TECHNICAL NOTE: DAVIDSTOW EPR ADDENDUM

DATE:	11 April 2023	CONFIDENTIALITY:	Confidential
SUBJECT:	Addendum to EPR/BN6137IK/V011		
PROJECT:	Davidstow EPR Variation Application	AUTHOR:	██████████
CHECKED:	██████████	APPROVED:	██████████

2.1 Creamery Project No.4 Whey Protein Concentrate (WPC35 → WPC60)

Figure 2-1 – Creamery Production Processes (updated to incorporate WPC60)

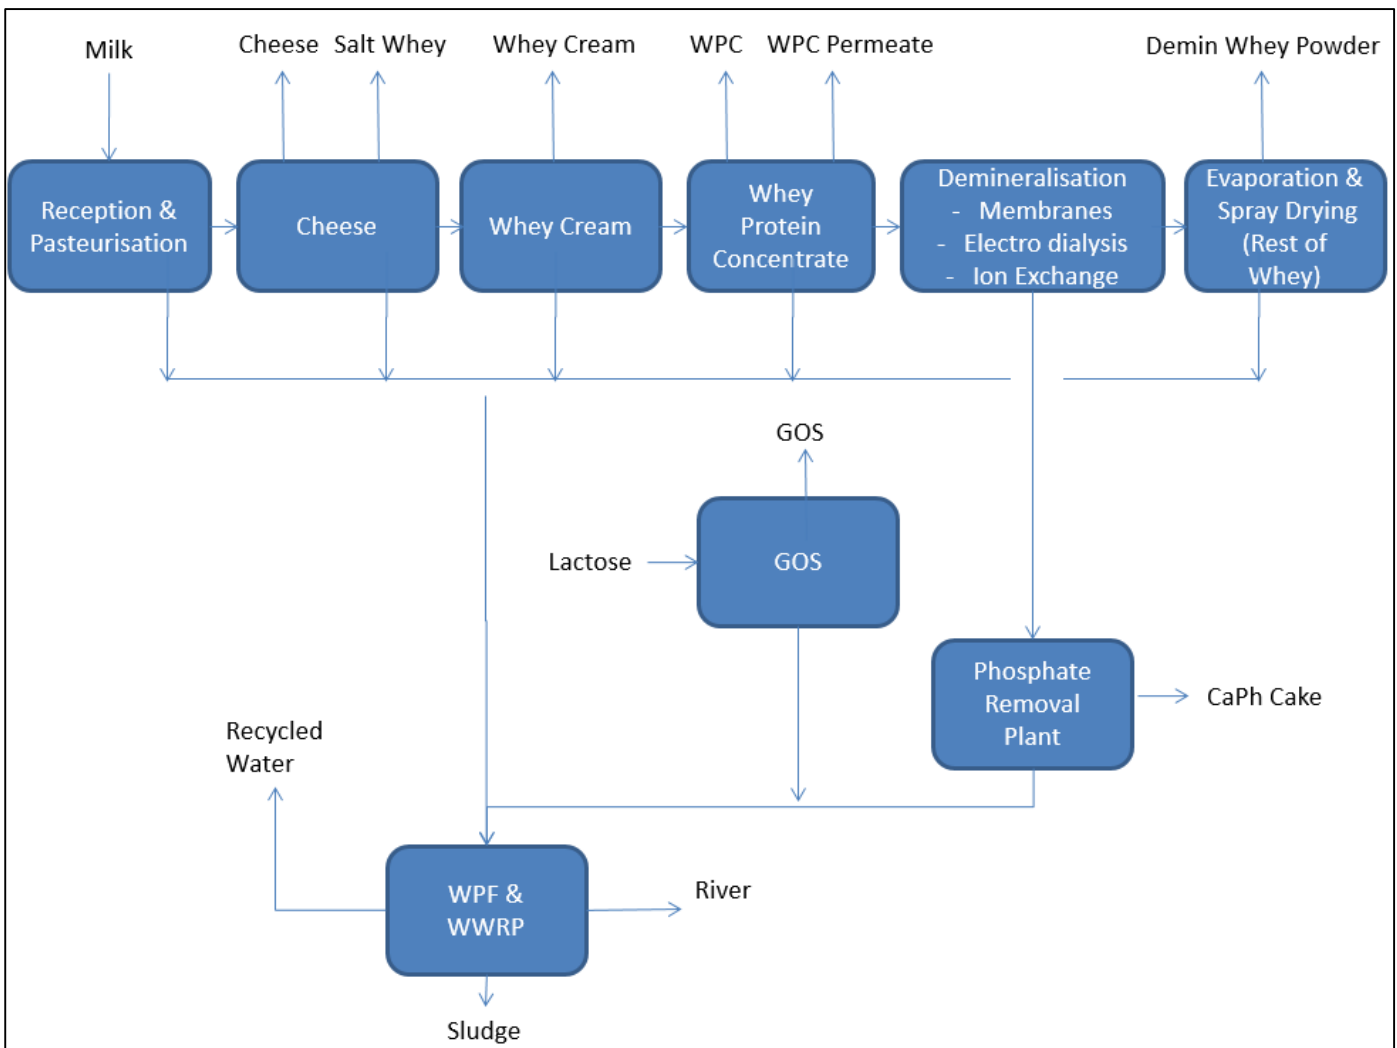
Water generated from the concentration of whey in the WPC60 process will be polished and re-used to clean the WPC60 equipment. An updated version of Figure 4-1 (Creamery Production Processes) included in the 2022 Variation Application is provided in Figure 2-1 below to reflect these changes, i.e. the additional WPC60 export stream.

Figure 2-2 – WPC60 Equipment Layout (Adjacent to Existing Demineralised Whey Process Area)

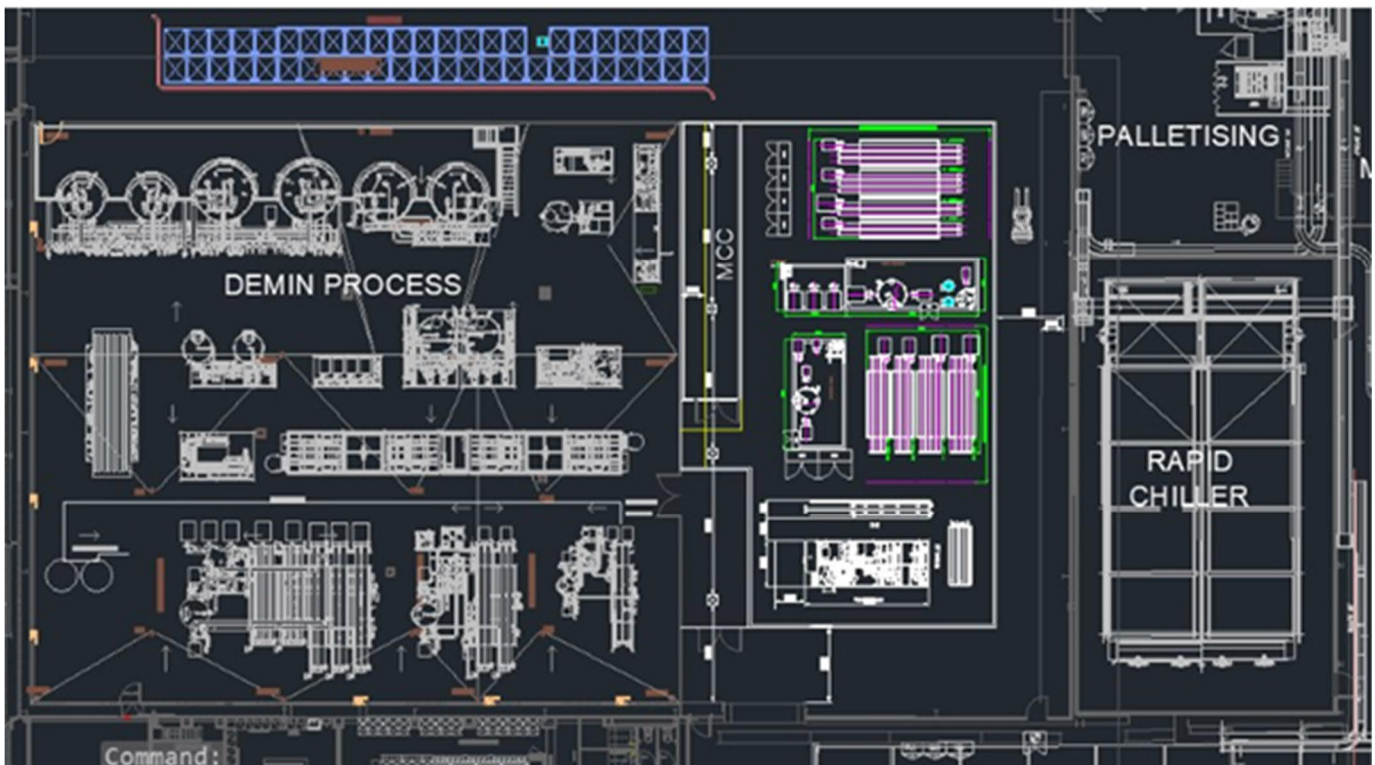
The new membrane and pasteurising equipment associated with this project will be located adjacent to the D90 process area building in a new process room. The layout of the new equipment and infrastructure is shown in Figure 2-2 below and Figure 2-3 provides a process flow diagram which shows the WPC60 process. The WPC60 processing plant is expected to be installed and operational by Autumn 2024.

Implementation of the WPC60 project requires the installation of the following additional equipment and infrastructure (as shown in orange in Figure 2-2 above):

- 1 x 225,000 litre raw whey storage silo;
- 1 x 45,000 litre/hr whey pasteuriser;
- 1 x 50,000 litre pasteurised whey buffer tank;
- 1 x 45,000 litre/hr NF membrane plant;
- 1 x 45,000 litre/hr NF/RO/ROP membrane plant;
- 2 x 50,000 litre re-purposed WPC60 storage silos;
- 2 x 200,000 litre concentrated permeate silos; and
- 2 x 200,000 litre polished RO water silos.

Figure 2-3 – Process Flow Diagram Showing WPC60 Process

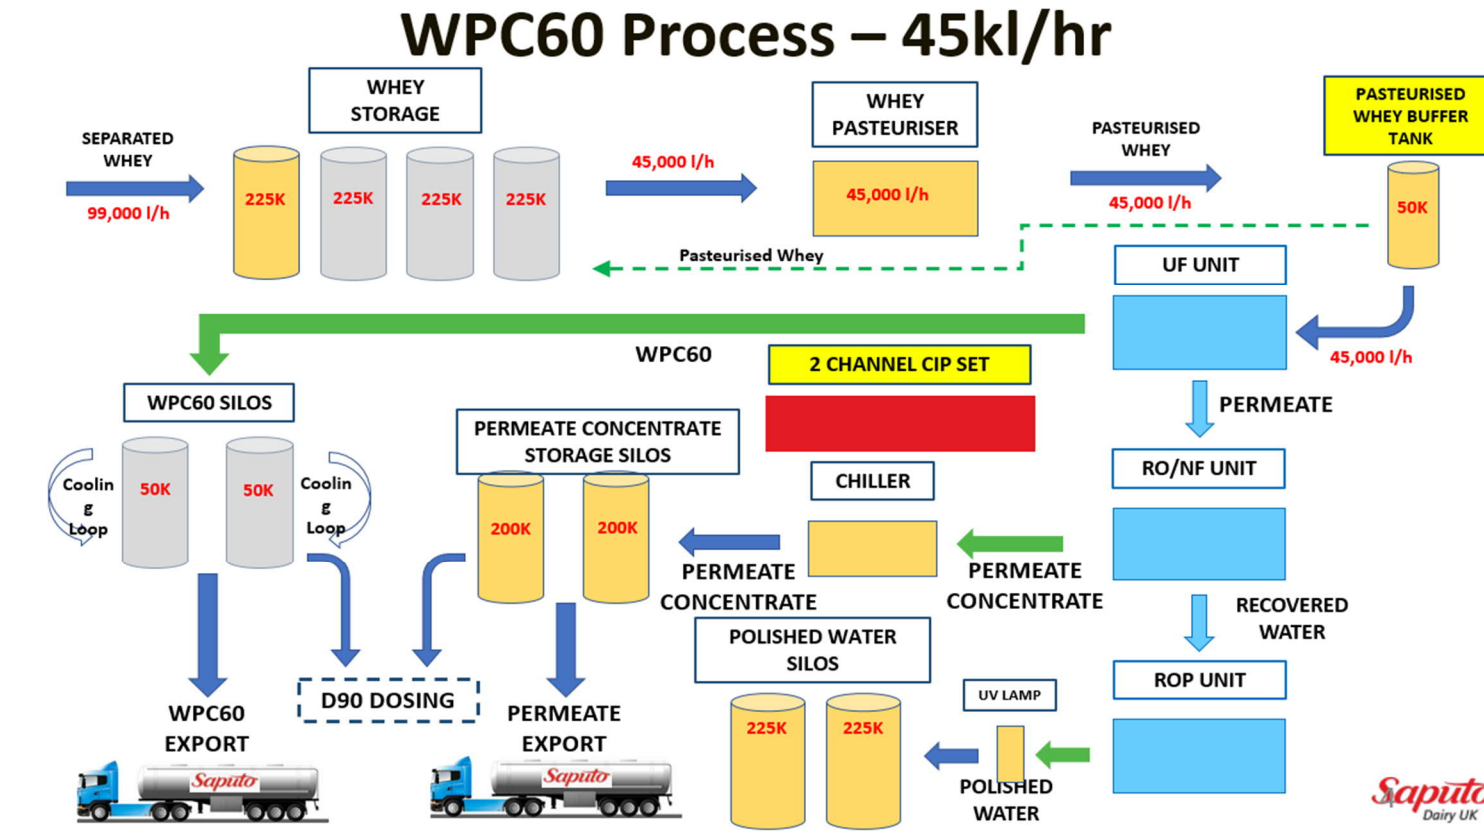
The WPC60 plant requires an additional whey storage silo to feed whey into the process. The whey will be heat treated through a whey pasteuriser and held in a buffer silo before going forward into membrane processing. The first membrane processing stage is nano-filtration (NF) where the whey is split into two product streams, retentate (concentrated whey proteins) and permeate (the remaining whey constituents such as water, lactose and minerals).

The permeate will be processed through a second stage of membrane processing using nano-filtration, reverse osmosis and water polishing (NF/RO/ROP). The NF removes any remaining protein and solids into

The permeate stream is then concentrated using the RO membranes with the removed water cleaned for re-use through the ROP. Concentrated permeate will be stored in two silos for re-use within the D90 powder process or export by road tanker to third parties.

Figure 2-5 – Anoxic Tanks AN2 and AN3 Before and After Installation of Cover

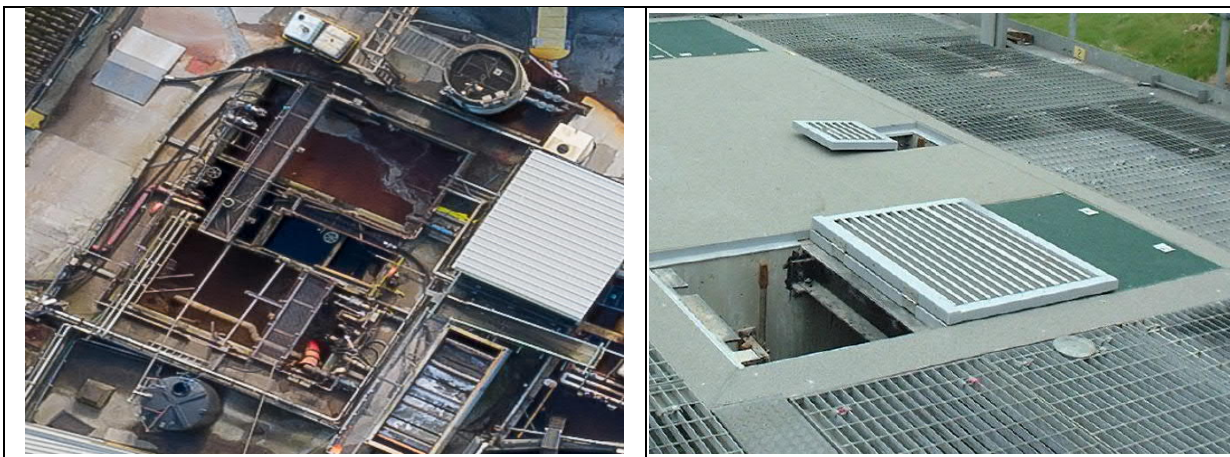
Ongoing olfactometric assessment, since submission of the 2022 Variation Application, has shown the next greatest contribution to residual odorous emissions to be Balance Tank 2 (BT2) which receives DAF treated effluent from BT1, and the two Anoxic Tanks AN2 and AN3. Although the emissions of odour per m² from BT2 are not significant, the surface area of BT2 adds to the magnitude of potential emissions. Therefore, in order to further reduce the potential for offsite odour emissions, as agreed in recent discussions with the Environment Agency, it is planned to install covers, extraction and abatement via a new OCU (designated Release Point A12) from BT2, AN2 and AN3. For completeness, the existing building housing DAF2 will also be extracted to the new OCU to benefit the working environment in that building. The project details are summarised in Table 2-5 below and photographs of the tanks before and after the envisaged covers are installed are shown in Figures 2-4 and 2-5.

Change / Improvement	Description and Benefits
Covering and extraction of BT2, AN2 and AN3	<p>BT1, AN2 and AN3 will be covered with Glass Reinforced Plastic (GRP) lids (BT2: non-walk-on cover and AN2/AN3: walk-on cover) and the air displaced from the covered headspace of the tanks will be treated via an OCU, in order to minimise odours, before discharge to atmosphere.</p> <p>The new OCU will comprise a single stage, dry chemical scrubber consisting of Diox and Triox media which remove H₂S (the principal odorous compound present) and other odours respectively. The scrubber is designed to achieve 99% removal of H₂S and 90 % of overall odours routed to the OCU. Based on average measured odour emission rates from 2019 to 2022, this represents a reduction of over 40% of the residual odour emissions from the WPF as a whole.</p> <p>An induced draught fan will draw treated air through the OCU at a rate of approximately 1,400 m³/hour (TBC – subject to detailed design). The fan will be sized sufficiently to accommodate maximum tank fill rate and aeration air added to BT2 whilst maintaining a slight negative pressure in the associated tanks and building. The fan will discharge treated air to atmosphere via a 6 m exhaust stack. The new OCU and exhaust stack (Release Point A12) will be located on top of the new load bearing covers over anoxic tanks AN2 and AN3.</p> <p>The Odour Impact Assessment submitted as part of the 2022 Variation Application included BT2, AN2 and AN3 as area emission sources and, therefore, this assessment is still considered to be valid. However, it provides a conservative assessment as, once these sources are covered, extracted and abated via the new OCU, the emissions and hence the environmental risk will be reduced even further.</p> <p>The new OCU (Release Point A12) associated with this project will be monitored in accordance with the monitoring arrangements specified in Table 5-1 (Monitoring Arrangements) of the 2022 Variation Application.</p> <p>This project is expected to be completed by December 2023 and is being expedited to achieve the associated reduction in odour emissions.</p>
